City of Portland, Maine – Building or Use Permit Application 389 Congress Street, 04101, Tel: (207) 874-8703, FAX: 874-8716

Location of Construction: 921 Congress St		Owner: Wornalee Saentong		Phone: 828-0458		Permit No: 981006	
Owner Address: SAA 04102		Lessee/Buyer's Name: Seng Thai Food II		Phone:		BusinessName:	
Contractor Name: David Vincent		Address: The Hamlet #35 Westbrook, ME		Phone: 854-5215		Permit Issued: SEP - 4 1998	
Past Use: Restaurant		Proposed Use: Saan		COST OF WORK: \$ 2,500.00		PERMIT FEE: \$ 35.00	
				FIRE DEPT. <input checked="" type="checkbox"/> Approved <input type="checkbox"/> Denied		INSPECTION: Use Group: Type:	
				Signature: <i>[Signature]</i>		Signature: <i>[Signature]</i>	
Proposed Project Description: Interior Renovations				PEDESTRIAN ACTIVITIES DISTRICT (P.A.D.) Action: Approved <input type="checkbox"/> Approved with Conditions: <input type="checkbox"/> Denied <input type="checkbox"/> Signature: _____ Date: _____			
Permit Taken By: NG		Date Applied For: 31 August 1998

BUILDING PERMIT REPORT

DATE: 9/3/98 ADDRESS: 921 Congress St.
REASON FOR PERMIT: renovations
BUILDING OWNER: Walmart Szentony
CONTRACTOR: David Vinnick
PERMIT APPLICANT: _____
U

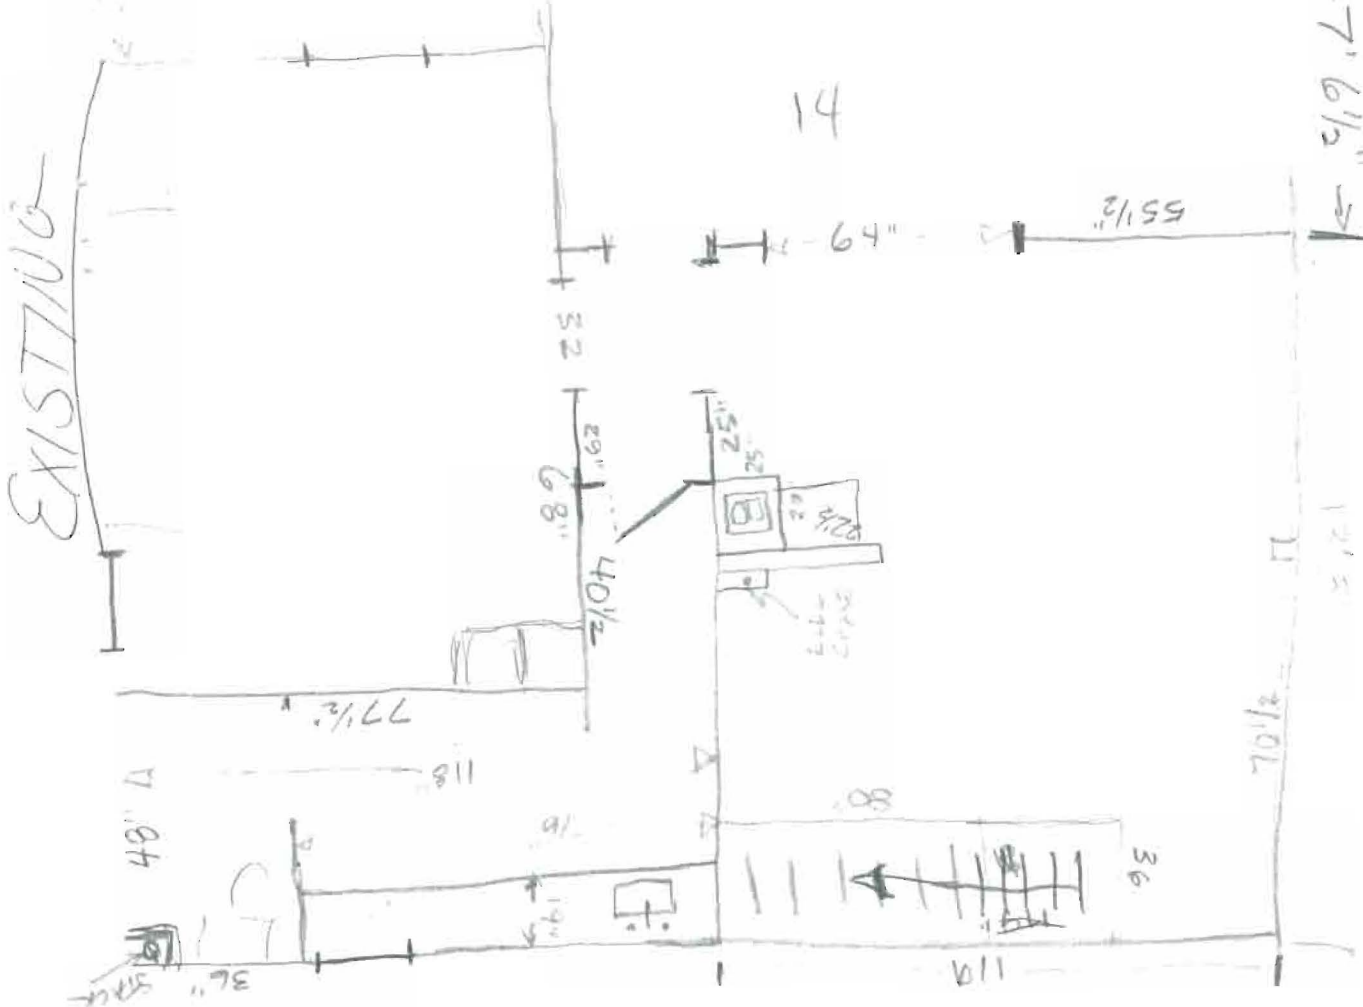
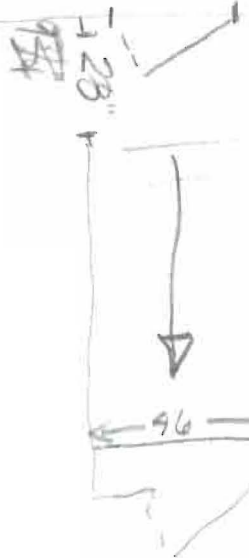
29. Basement storage shall be separated with a fire rating of at least one hour

30. All Kitchen Exhaust equipment, shall meet the requirements of Chapter 5 of The City's Mechanical Code. (The BOCA mech. code/1996)

31. A Two (2) hour fire resistance rating shall be maintained between the restaurant and living space
